Final Peer Review Report
For the District's
Recommended Minimum Flows for
Horse Creek

AGREEMENT NUMBER: 23CN0004217
SOUTHWEST FLORIDA WATER MANAGEMENT DISTRICT
2379 BROAD STREET
BROOKSVILLE, FLORIDA 34604

NOVEMBER 2023

Figure 2.2 Flow Blocks superimposed on a hydrograph of median observed daily flow representing a typical calendar year. The horizontal lines represent Flow Block divisions.

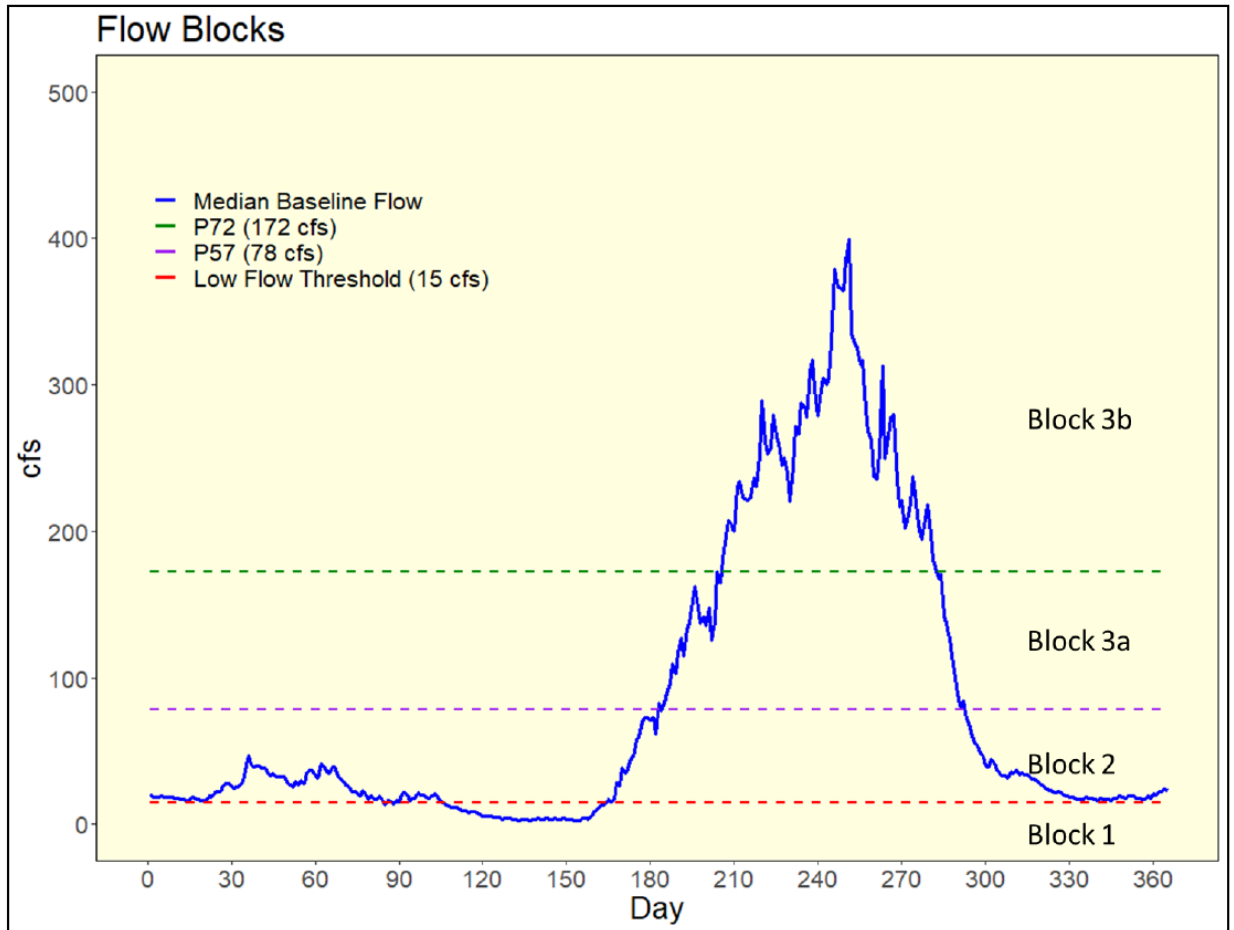
The structure of the 4 Flow Blocks (Figure 2.2) is well-conceived and protective of all Water Resource Values. This is a progressive and robust assessment. Blocks 1 and 2 were protected by evaluating multiple specific habitats and functional features in each block and were set using the most protective metrics at the most-sensitive location among multiple positions in the study area. The approach taken there is specific, prudent, balanced, and highly intuitive toward addressing the key functions in those blocks.

Blocks 3A and 3B were derived primarily from a statistical analysis of the lower and upper portions of the floodplain area inundation, without directly addressing the requirements of specific habitats or processes in that part of the flow regime. Further, block-specific average percent of flow reductions were, respectively, recommended as the minimum flow for Blocks 3A and 3B. This results in a less protective approach versus using the highest flow in each block.

Block 3A includes the lowest-lying and most-deeply and frequently-wetted alluvial floodplain surfaces and communities that are wetted between the 56th and 72nd percentile flow. This block straddles bankfull flow. Bankfull flow is perhaps the single most important discharge for sustaining in-stream channel pattern and dimension, and its distribution of habitat substrates. It warrants specific attention and appears to be indirectly but sufficiently protected by this approach in this case.

Block 3B contains habitats that occupy elevations associated with 72nd to 99th percentile flow profiles. Substantial active alluvial surfaces occur above the average flow stages in that block and the uppermost alluvial substrates and associated biological communities may be unprotected at a 15% reduction of inundation area by using the PFR of the average flow in the block.

Figure 2.3: Floodplain Community Relative Elevations to Flow Percentile

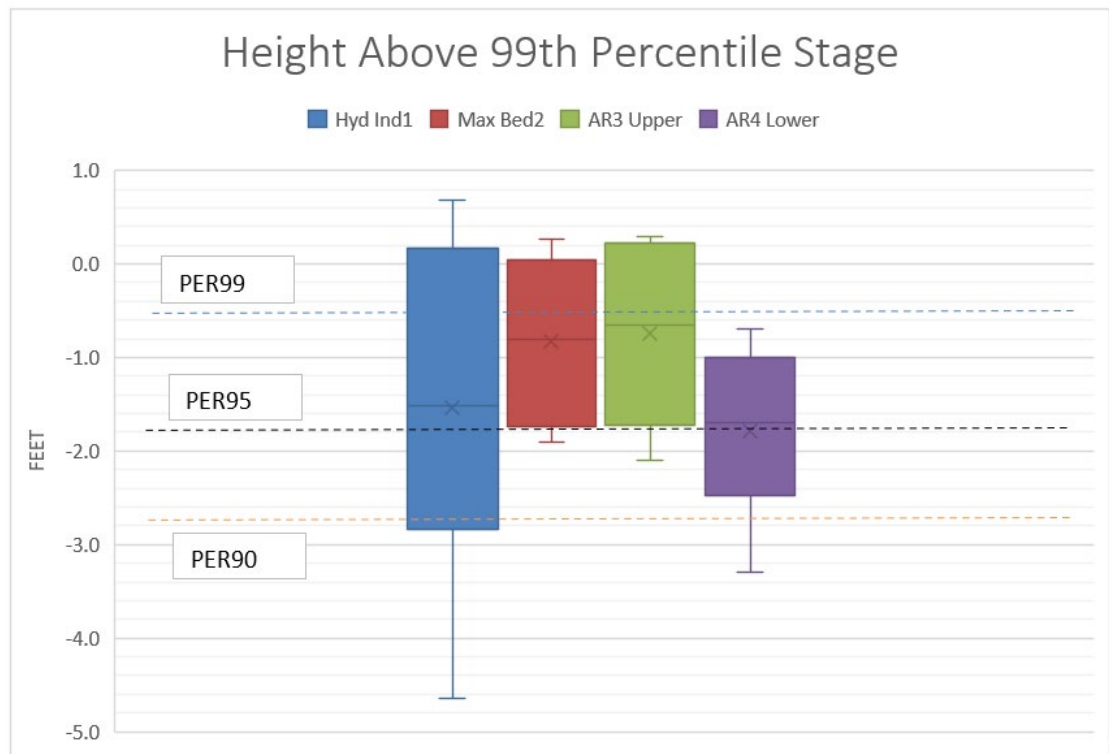
The Panel examined the results of the HEC-RAS model at the vegetation survey sections to confirm protection of each of the major floodplain habitats identified in the vegetation and soils study. The uppermost alluvial ridges (AR3) and their associated hydric hammocks (Max Bed2) occur between the 95 and 99 flow percentiles (**Figure 2.3**).

The District is to be commended for the specificity and wide blanket cast to protect features in Blocks 1 and 2, building upon proven precedents and adding to the sophistication of previous analyses. The methods used for Blocks 3A and 3B are also well thought out for seeking a simple and elegant evaluation method drawing from modeling results, but are not as multiple and as habitat-specific as in the approaches used in the lower in-stream blocks.

There is greater uncertainty in this lack of multiple variables and spatial aggregation, and Block 3B has a considerable range of percent-of-flow reduction versus flow percentile across the flow range in the block.

Figure 2.4: The sensitivity between the percent-of-flow reductions that would result in a 15% decrease in the amount of total inundated wetlands and river flow percentiles in Horse Creek. Note the fitting of the 3 lines for low, mid, and highflow percentile portions of the sensitivity curve.

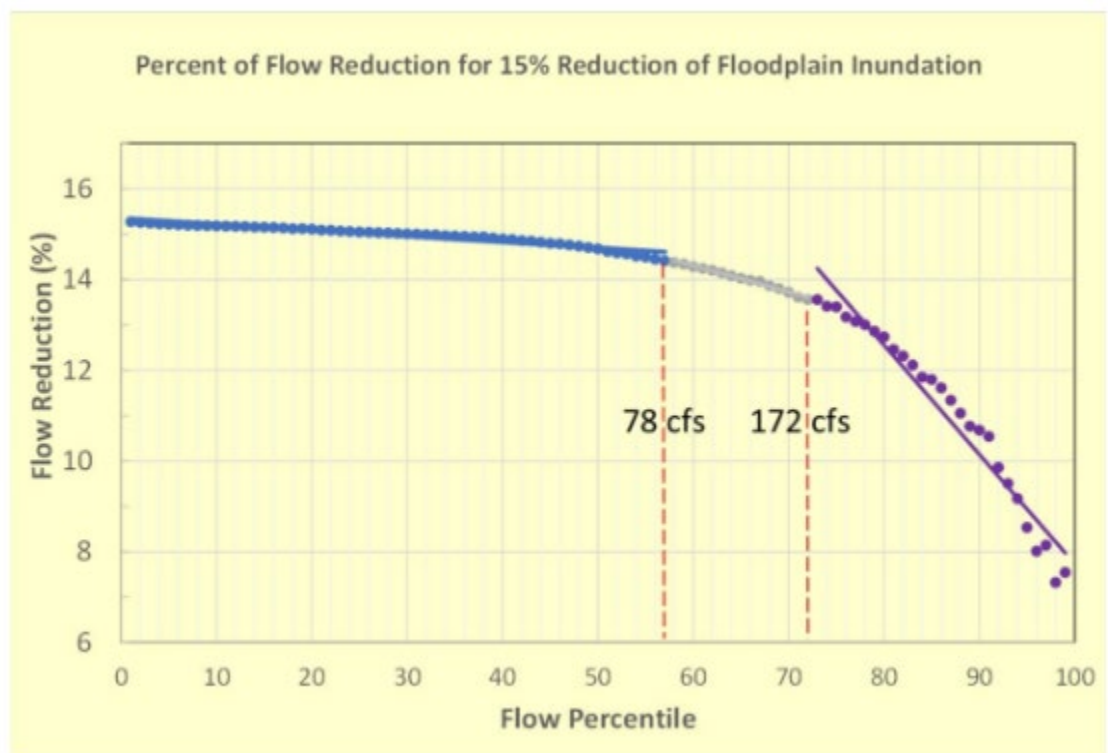
For Block 3A, the Panel finds the narrow range of 14% to 13.5% percent-of-flow reduction does not warrant any further consideration as the result is insensitive to the method taken to select which percent of flow reduction to use within that range. However, Block 3B covers a range of approximately 13.7% to 7% flow reduction and more care is required in the selection of what part of this range is sufficiently protective of the surfaces and habitats spanning the associated flow range (**Figure 2.4**).

To provide greater assurance against significant harm to the upper-most habitats, the Panel would like the District to consider splitting the upper portion of that Block into a third floodplain block, Block 3C. A visual break is apparent somewhere near the 90th to 92nd flow percentiles. A break near that position would better center the allowable flow reduction for the upper alluvial surfaces and habitats in the floodplain without unnecessarily restricting withdrawals throughout the entire range of existing Block 3B.

The anticipated result would be mid-point floodplain inundation protections of the three main flood terraces in the system including the lowest alluvial surfaces such as the bankfull channel margins, lower backswamps, chutes, and deeper bottomlands (covered by existing Block 3A); middle terrace features including valley flats, lower alluvial ridges, and shallower backswamps (in the proposed reduced Block 3B); and the upper terrace's alluvial ridges and valley flats (in new Block 3C). Block 3C was added by the District to address this concern by the Panel.
